**Report: TAB Report**  
**Function: Test, Adjust, & Balance**  
**Date: 02/24/2026**  
**Completed By: National TAB**

**02-23-26 QT #0460 TEMPE, AZ**

QUIKTRIP  
4705 SOUTH 129TH EAST AVENUE  
TULSA, OK 74134

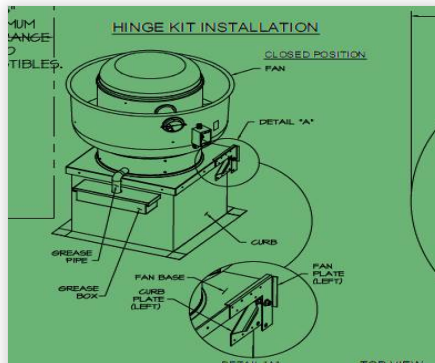
**Issue Name :** EF3 HINGE/GREASE CUP NOT PROPERLY INSTALLED  
**Description :** HINGE SHOULD BE INSTALLED OPPOSITE THE GREASE CONDUIT/CUP.  
**Created By :** National TAB **Assigned To :** National TAB - Dan Hertenstein  
**Status :** Open  
**Priority :** Low **Asset Tag :** EF3  
**Originated Date :** 02/24/2026 - Christine Weale - National TAB

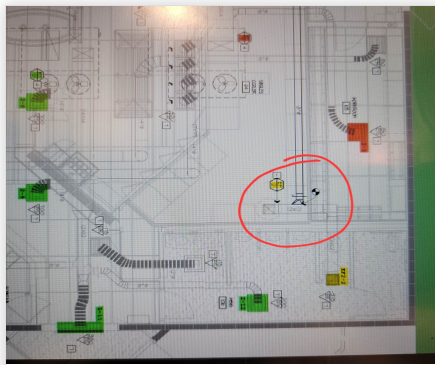
**Issue Name :** INACCESSIBLE DAMPER  
**Description :** Damper not installed in MSET location. Tried to trace, dampers inaccessible. Pic shows where Dampers should be located. Most of these QTs have OBDs installed in grille, those are recommended to guarantee accessibility.  
**Created By :** National TAB                      **Assigned To :** National TAB - Dan Hertenstein  
**Status :** Open  
**Priority :** High                                      **Asset Tag :** EF2  
**Originated Date :** 02/24/2026 - Christine Weale - National TAB

Asset: EF2

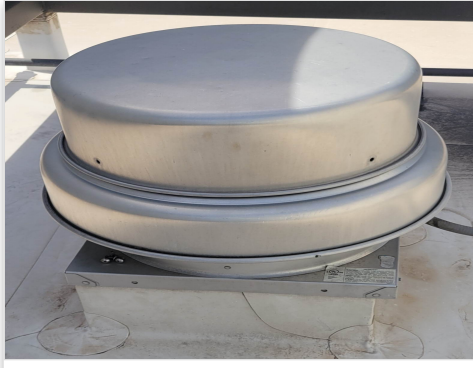
TOTAL FLOW BALANCED, SEE 'REMARKS'. ONCE DAMPER IS LOCATED AND ADJUSTED TO ALLOW FLOW FROM COMBI-OVEN, NO FURTHER CHANGES SHOULD BE NECESSARY.
